ADDENDUM #1

PROJECT MANUAL FOR: CP221951 UMPB Ground Floor Renovation

CP221951 UPMB Addendum # 1

PROJECT: UPMB Ground Floor Renovations
PROJECT NO: MUHC – CP221951, R&B - 1202.0011414.000
DATE: September 16, 2022
BY: Tori Gillespie, Chris Philipp
RE: Addendum #1
DWG REF: See below
SPEC REF: See below
CC: Central File

1 MECHANICAL - GROUND FLOOR PLAN - NEW WORK

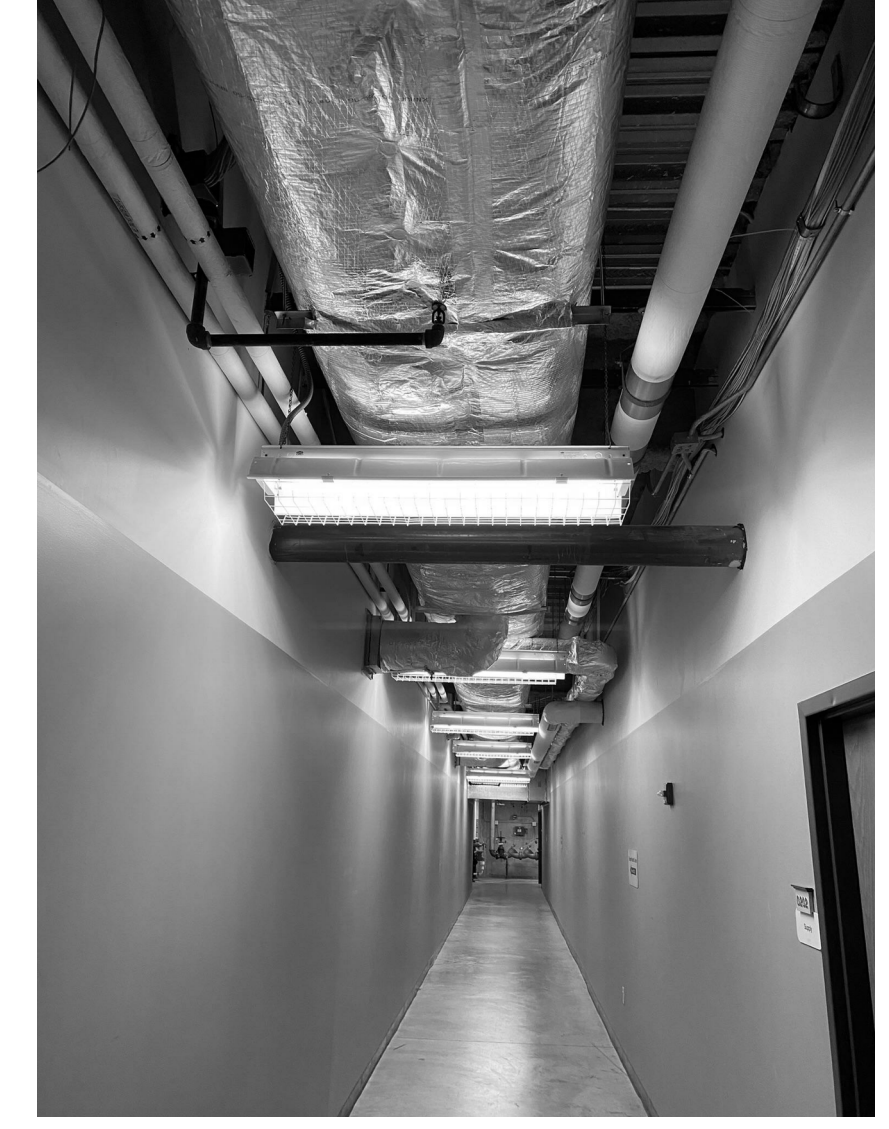
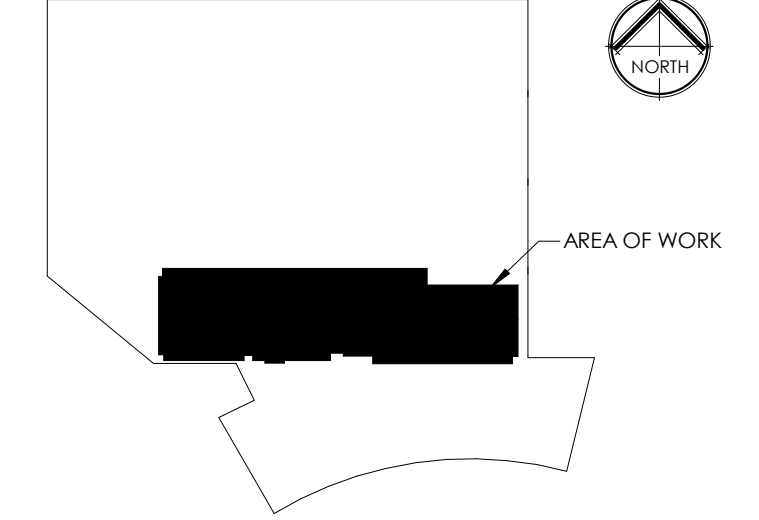
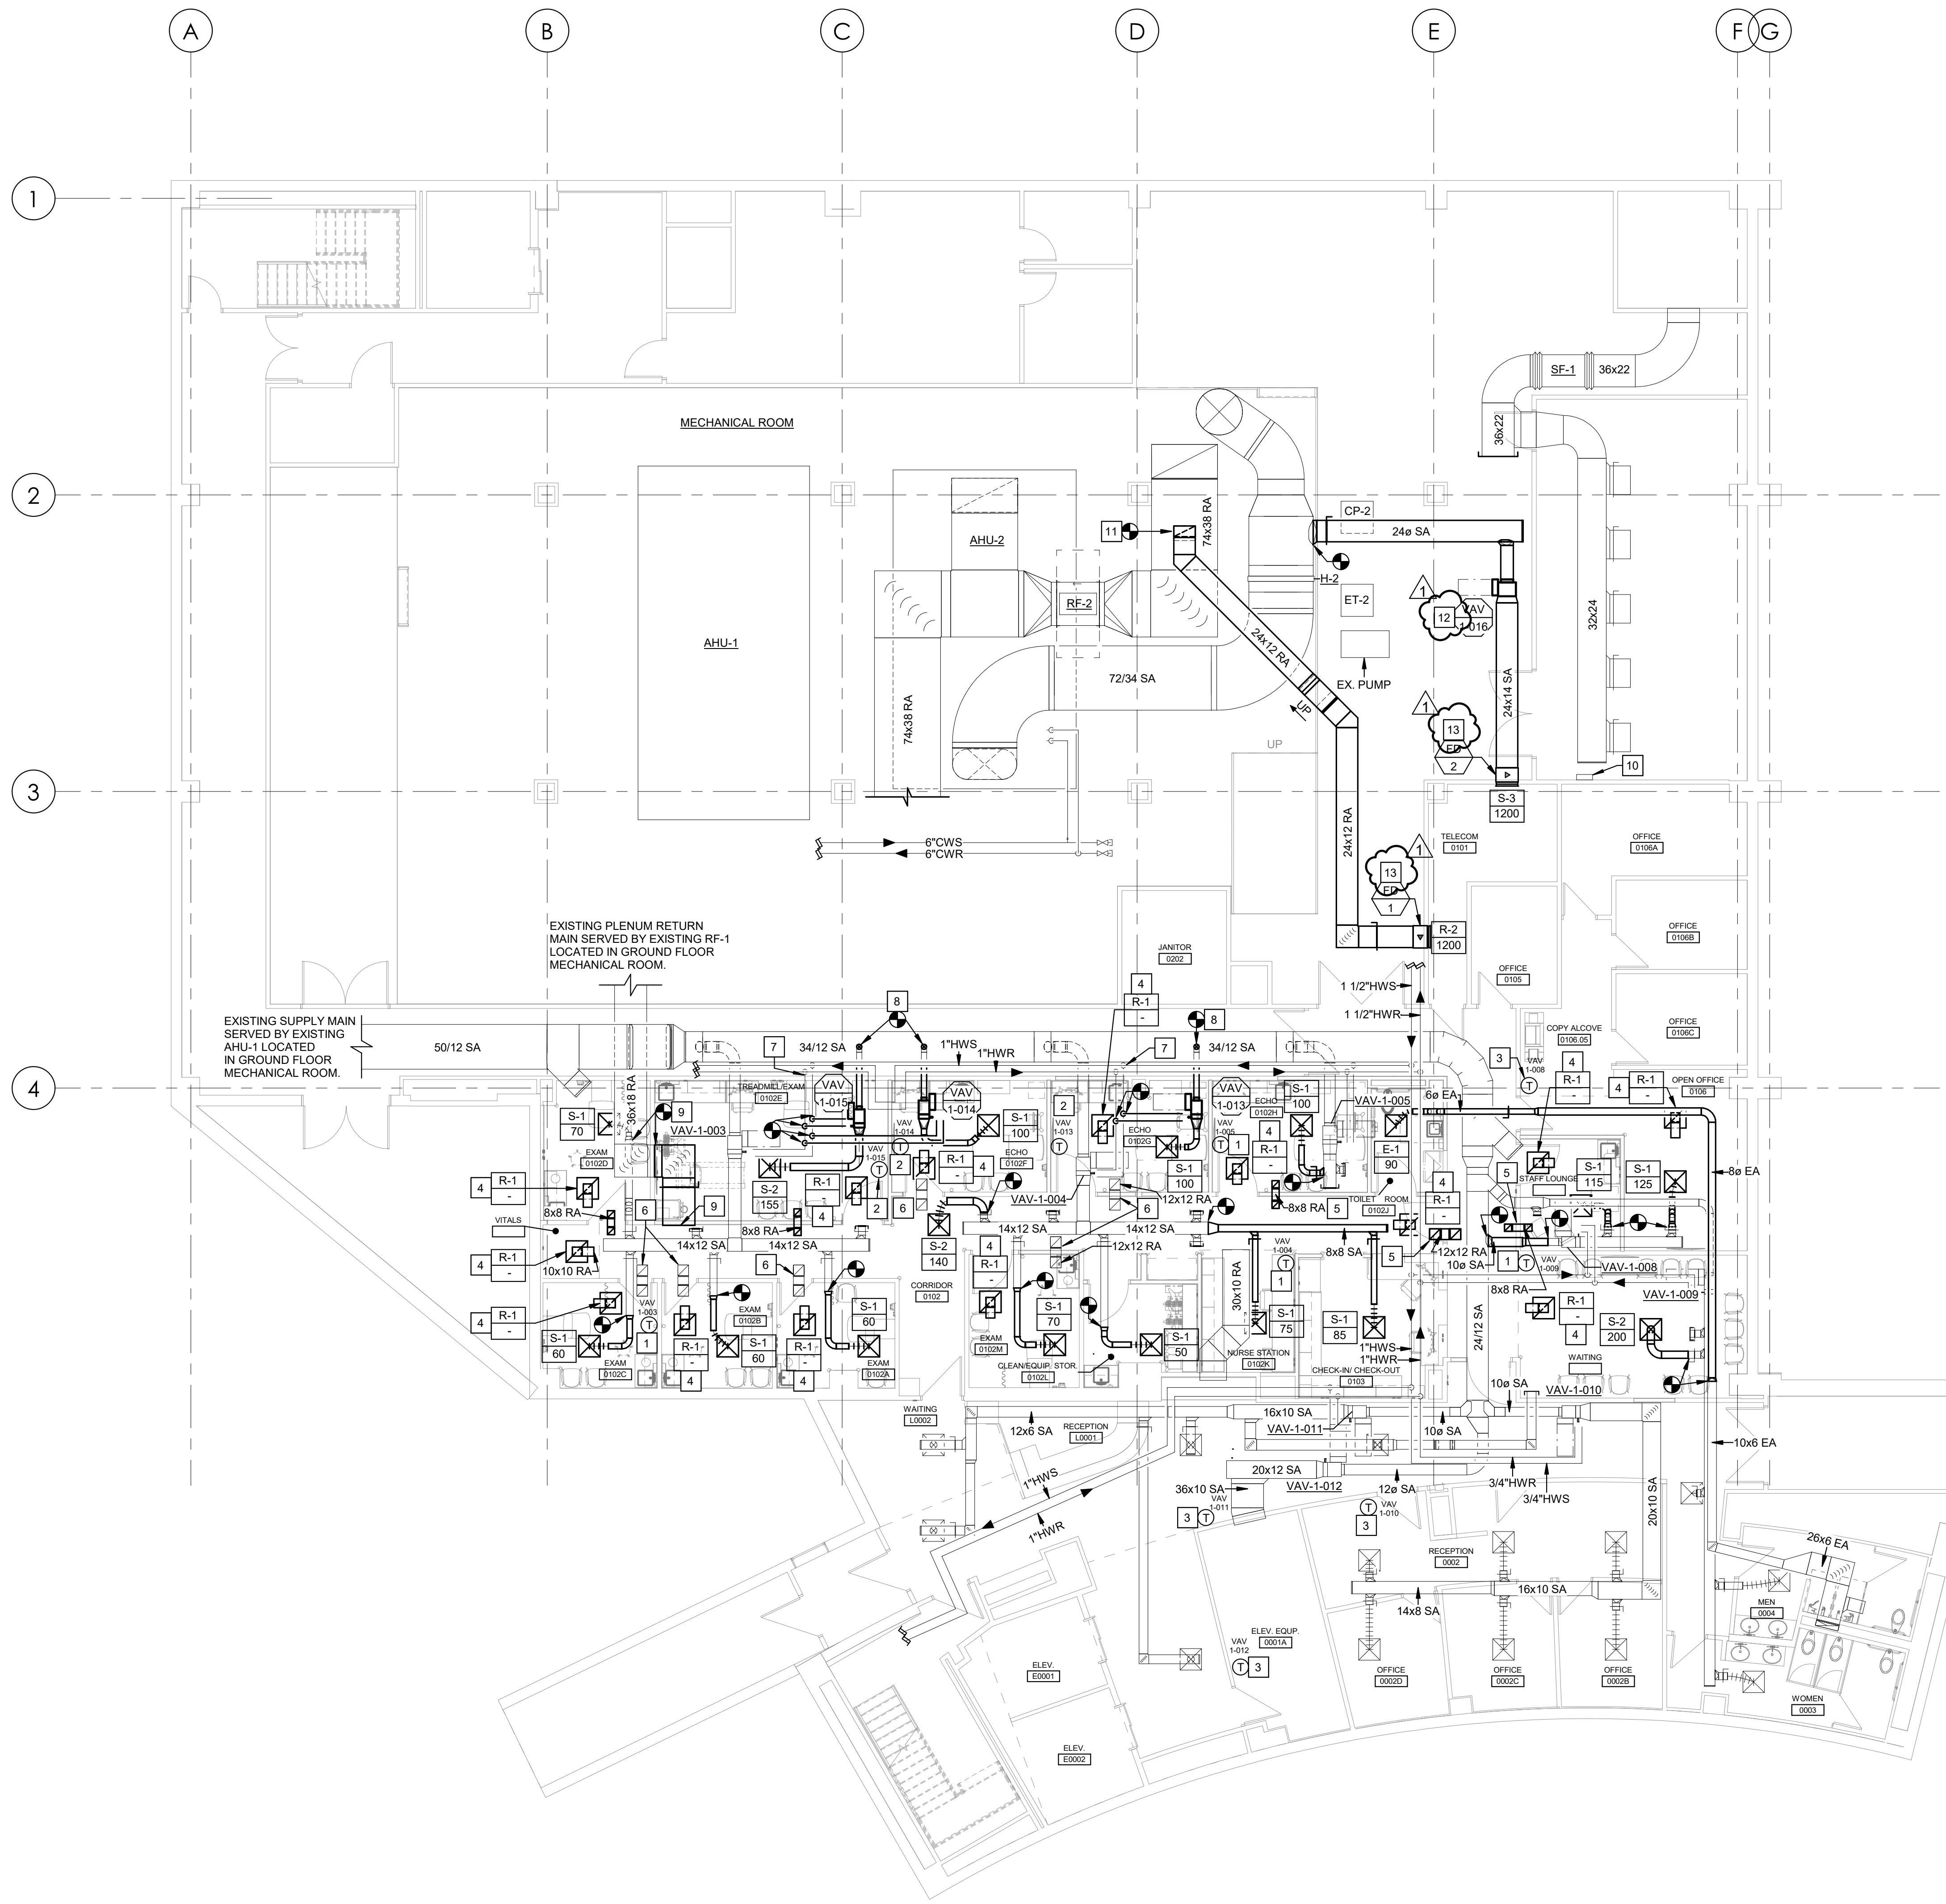
1. M100
 - a. REVISED keyed notes 7 and 8.
 - b. ADDED keyed notes 11, 12, and 13.
 - c. ADDED images 3, 4, and 5.
 - d. Refer to reissued sheet dated 09-16-2022.

7. PRIOR TO CONNECTING TO EXISTING EXPOSED 3/4" HEATING HOT WATER PIPING, CLOSE EXISTING SHUT-OFF VALVES IN EXISTING NORTH CORRIDOR. EXISTING HEATING HOT WATER SYSTEM MUST REMAIN OPERATIONAL AT ALL TIMES. REFER TO IMAGE 1 AND 2 ON SHEET M-100.

8. REMOVE EXISTING BRANCH DUCT TO BE BELOW EXISTING SUPPLY MAIN. REFER TO IMAGES 4 AND 5 ON THIS SHEET.
9. CONNECT TO EXISTING OPEN-ENDED RETURN AIR DUCT ABOVE CEILING AND EXTEND AS SHOWN. BALANCE FOR 4135 CFM.

10. EXISTING VAV DDC POWER SUPPLY ON WALL.
11. CONNECT NEW RETURN BRANCH DUCT TO TOP OF EXISTING RETURN MAIN.
12. ROUTE NEW 24"Ø SUPPLY BRANCH DUCT ABOVE EXISTING STEAM PIPING AND BELOW EXISTING CONDUIT. REFER TO IMAGE 1 ON THIS SHEET. NEW VAV-1-016 TO BE INSTALLED AT SAME ELEVATION THAT EXISTING 18x14 OUTSIDE AIR DUCT WAS REMOVED. REFER TO IMAGES 2 AND 3 ON THIS SHEET FOR OUTSIDE AIR DUCT. REFER TO SHEET M-100 FOR OUTSIDE AIR DUCT DEMOLITION WORK.

13. MODIFY EXISTING OPENING IN WALL FOR INSTALLATION OF NEW RATED DAMPER.
